## CLARIFICATION OF GRID CODE FREQUENCY RESPONSE REQUIREMENTS

### Paper by National Grid

## ATTACHMENT A – Proposed Legal Text Changes for Option 3

Figure CC.A.3.2 - Interpretation of Primary and Secondary Response Values

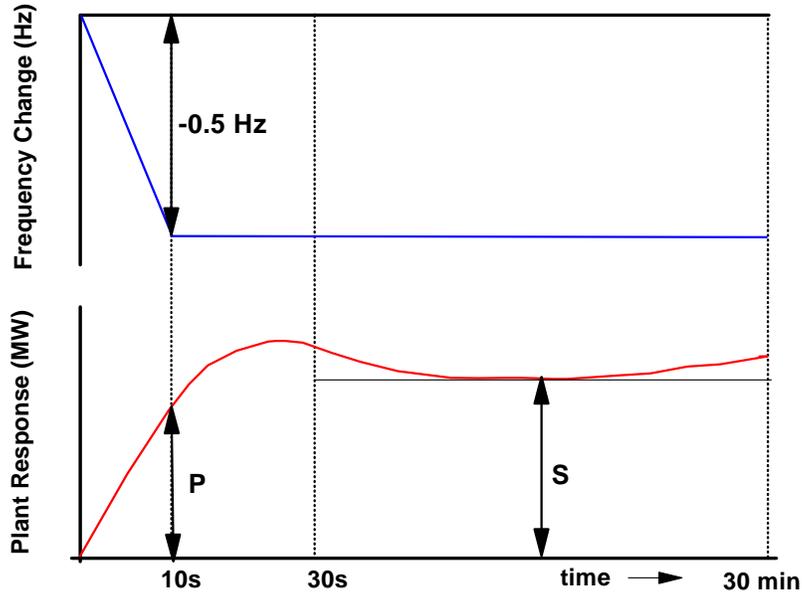
20. Based on discussions with some Generators, the profile of the frequency response over the period 0 to 10 seconds also needs clarification in wording in addition to the profile shown in Figure CC.A.3.2.
21. NGET proposes that this is clarified by inserting the words “at least linearly” in both CC.A.3.4 and the Glossary and Definitions as shown in the attached legal text.

The **Primary Response** capability (P) of a **Generating Unit** or a **CCGT Module** or **Power Park Module** or **DC Converter** is the minimum increase in **Active Power** output between 10 and 30 seconds after the start of the ramp injection as illustrated diagrammatically in Figure CC.A.3.2. This increase in Active Power output should be released at least linearly with time over the period 0 to 10 seconds from the time of the start of the Frequency fall as illustrated by the Plant Response in Figure CC.A.3.2. If there is an initial inherent delay in the increase of Active Power output following a Frequency fall, this must be minimised as far as is reasonably practicable and in any event such a delay should be no longer than two seconds unless in NGET's reasonable opinion a longer delay is unavoidable.
